PARTS BULLETIN

No: 6-22

Subject: Blade Retaining Pin #27055

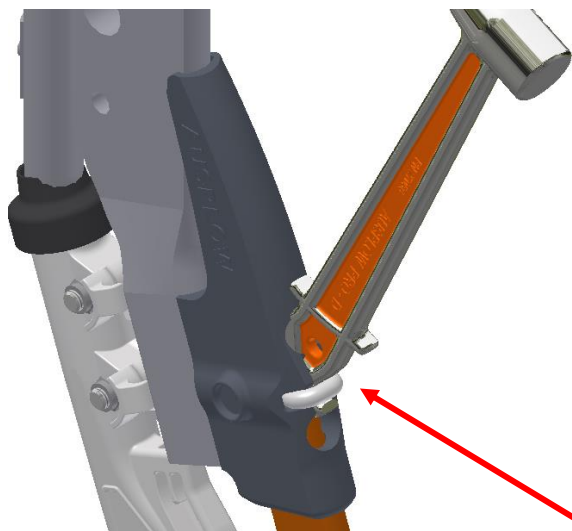
Shown below is an example of a Blade Retaining pin coated in a typical anti-seize paste. Please note where on the pin the paste is to be applied.

This Bulletin is to inform Dealers and their Ausplow customers who have the PRO-D blade that it is highly recommended the 27055 pins that hold the Pro-D Blade in the blade adaptor are coated with a film of anti-seize paste whenever they are inserted into the blade adaptor.
